Subject: **Surface Water Validation Report for Mayfield West Waste Facility Condition B35 of SSD-7698**

Subject: EPL 20771 - Water management update

Subject: Mayfield West Recycling Facility: Surface Water Validation Report review outcomes

Figure 1.1 Proposed water use areas

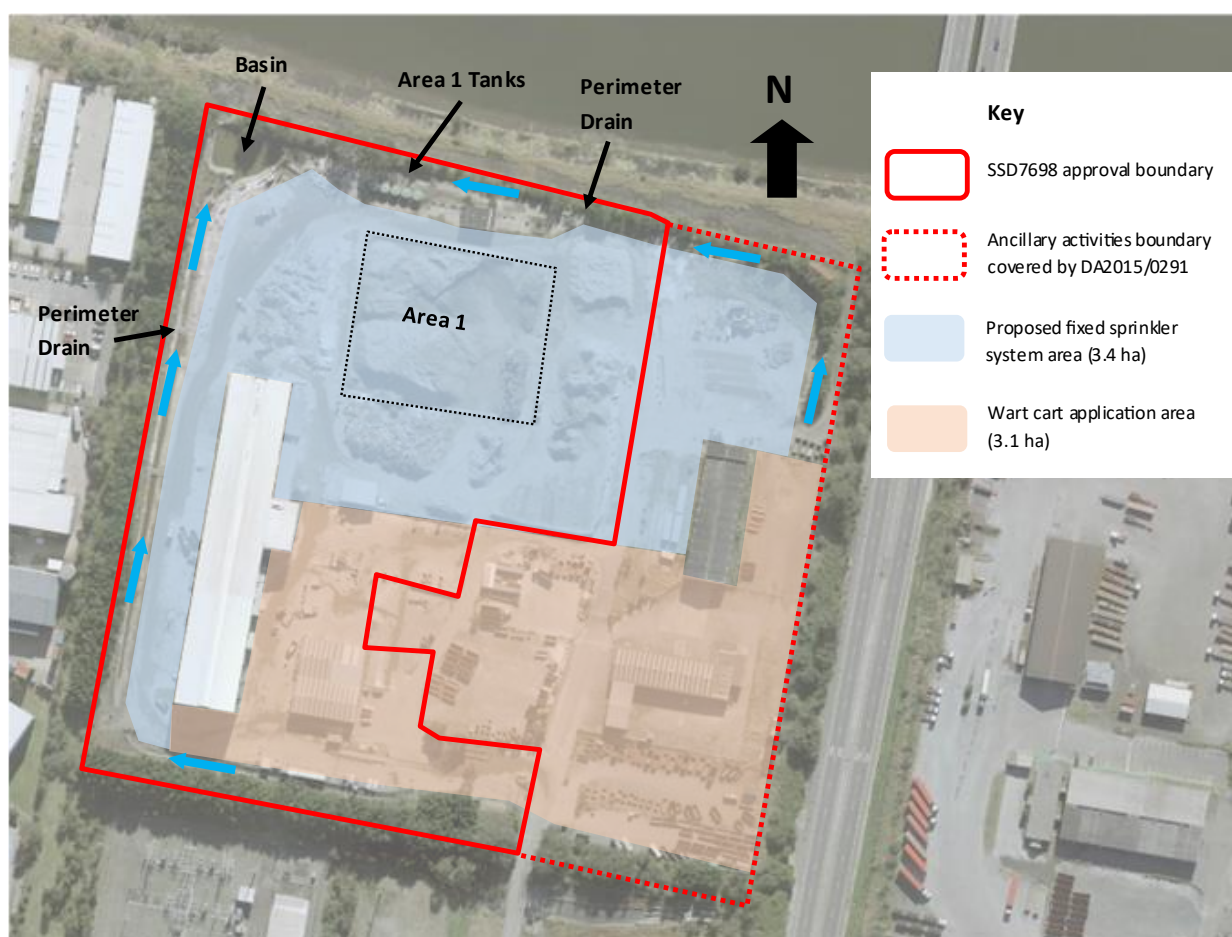
Benedict have reviewed options to increase water use following rainfall to reduce the time taken to restore the basin capacity. It is proposed to:

- install a new fixed sprinkler system that will apply water to approximately 3.4 ha of the site; and
- repurpose the water cart to apply water only to the south-eastern portion of the site, where it is not practical to operate a fixed sprinkler system. This part of the site has a total area of 3.1 ha. However, the water cart will only apply water to the roads and hardstand areas and the application area is estimated to be 1.5 ha (out of the greater 3.1 ha area).

Figure 1.1 shows the abovementioned areas. It is noted that the water application is proposed in both SSD 7698 approval boundary (in which the waste management facility is operated) and the ancillary activities area, which is owned and operated by Benedict under a separate approval. Runoff from both areas drain to the basin via the perimeter drainage system.

Figure 4.1 Revised water management system framework

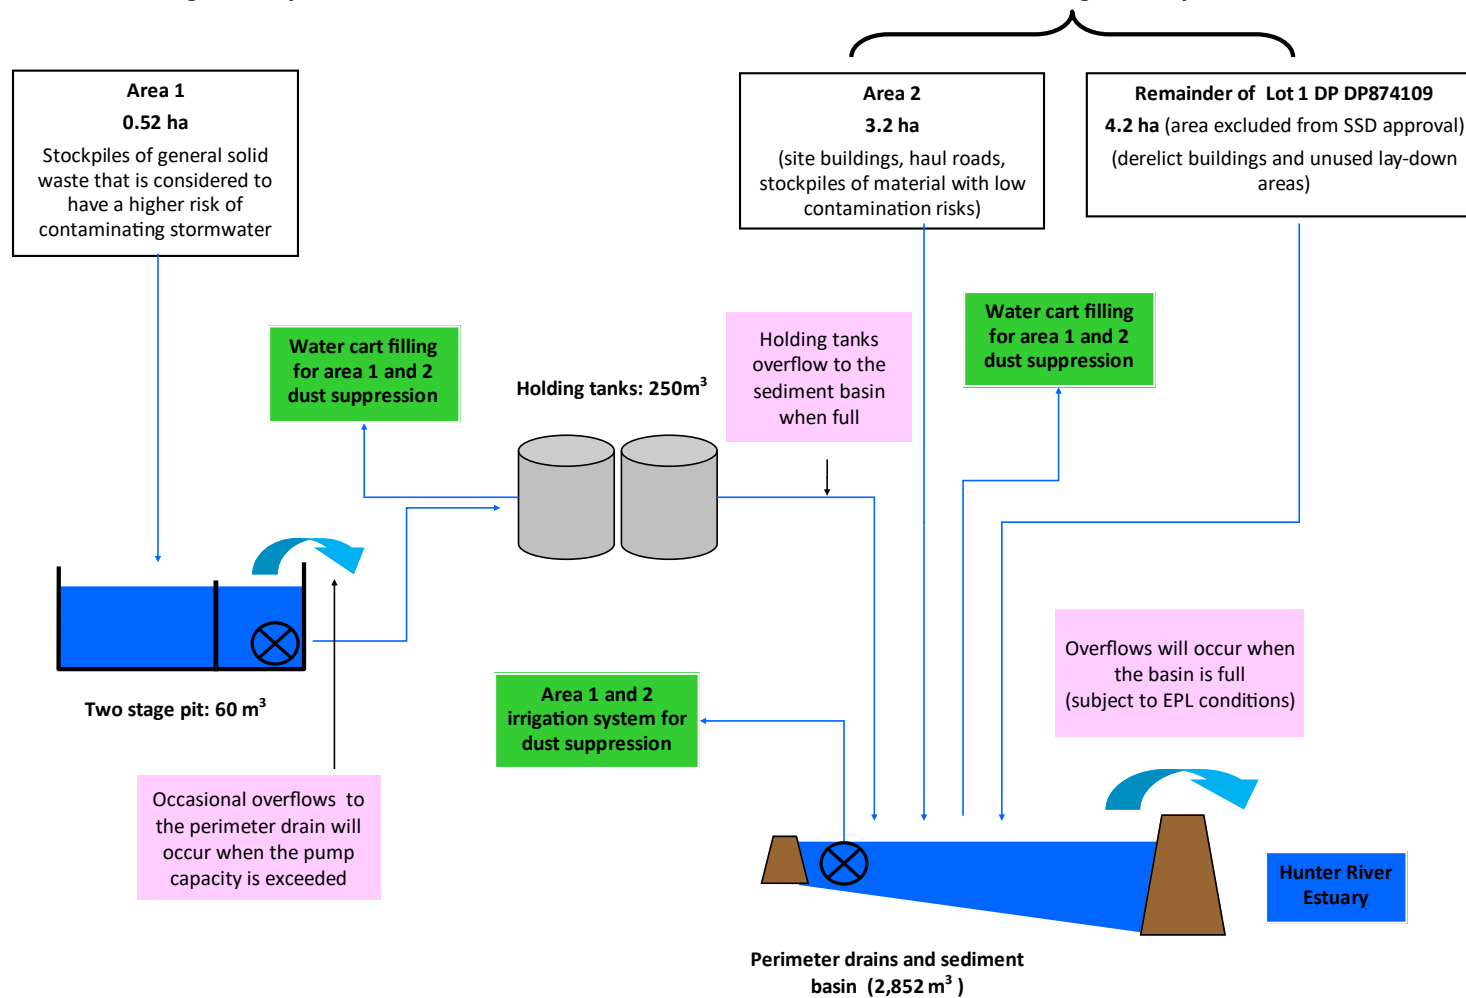
2.2 – Controlled discharges from the basin water treatment system	<p>As described in Figure 2.1, the water management plan makes provision for controlled discharges from the basin when water quality is suitable.</p> <p>The current management practice is to use water captured in both the basin and the Area 1 tanks for dust suppression following rainfall. This is the most practical management approach as it avoids the need for rapid water quality testing and potentially water treatment.</p>	<ul style="list-style-type: none"> Controlled discharges are removed from the water management plan and the basin is managed to minimise the frequency and magnitude of overflows by maximising the on-site use of water captured in the basin. Monitoring of key analytes of concern is undertaken when basin overflows occur.

Figure 4.1 shows an updated conceptual framework of the water management system with the above recommendations implemented.
